**FIRE STATION SWALE PROJECT
HYRUM CITY, UTAH
ADDENDUM #1**

Hyrum Fire Station Swale Project

C-103

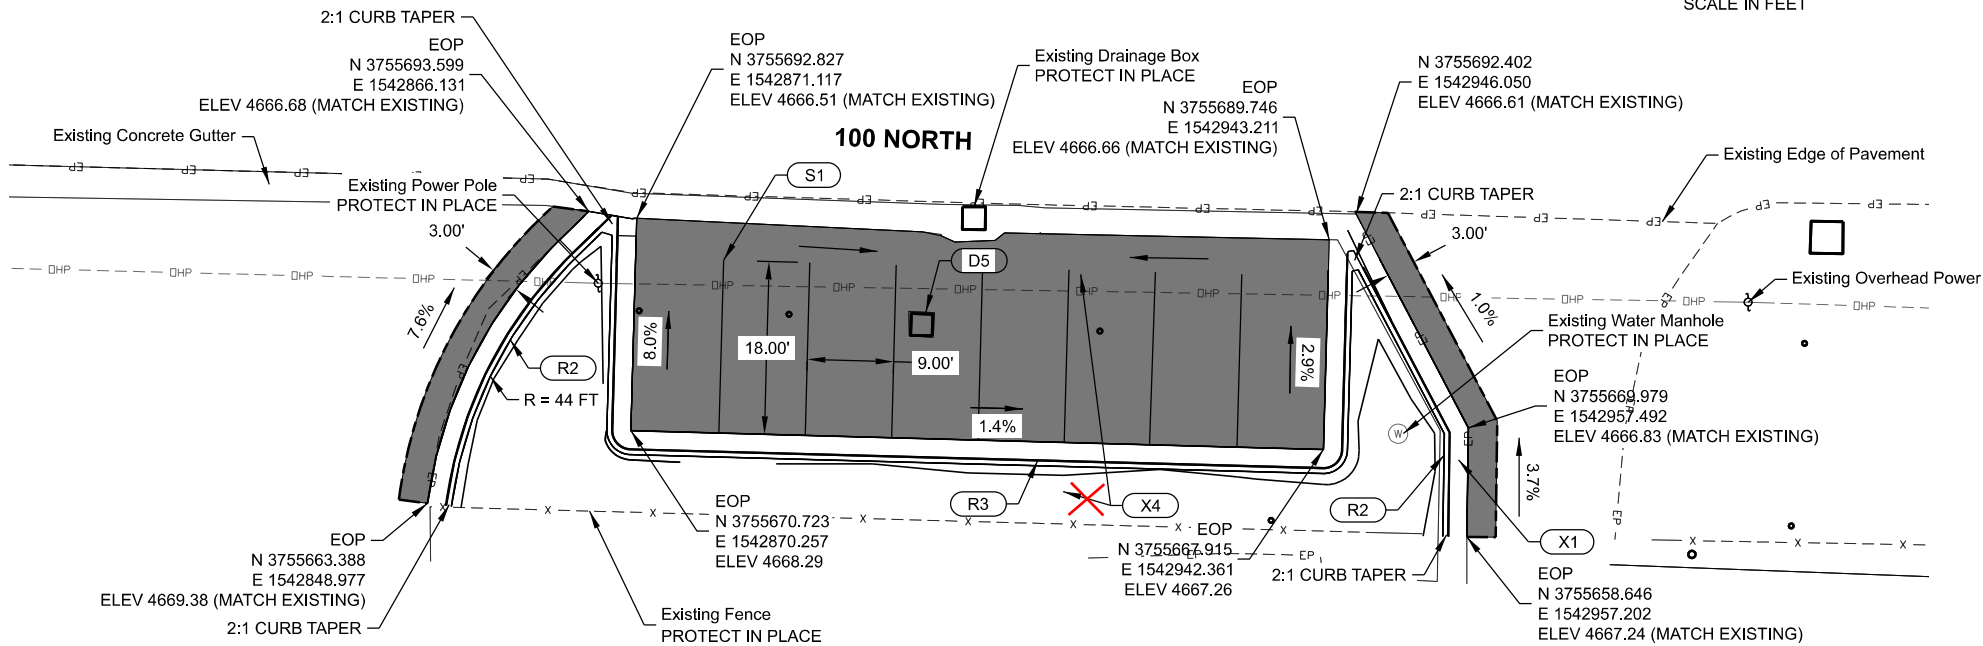
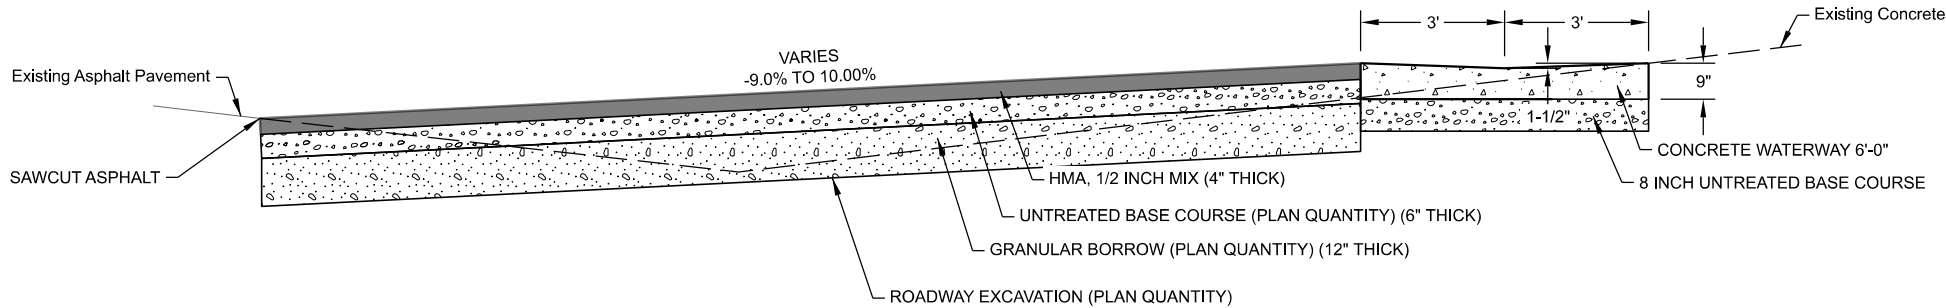
- A. Change Bid Item name X4 on sheet C-103 and end condition callout on sheet C-401 as indicated on attached document C-103 and C-401 from "STRIP, STOCKPILE, AND SPREAD ROCK MULCH WITH WEED BARRIER FABRIC" to "REMOVE LANDSCAPE ROCK".
 - 1. C-103 – Plan View
 - 2. C-401 – Typical Section

- X4 REMOVE LANDSCAPE ROCK
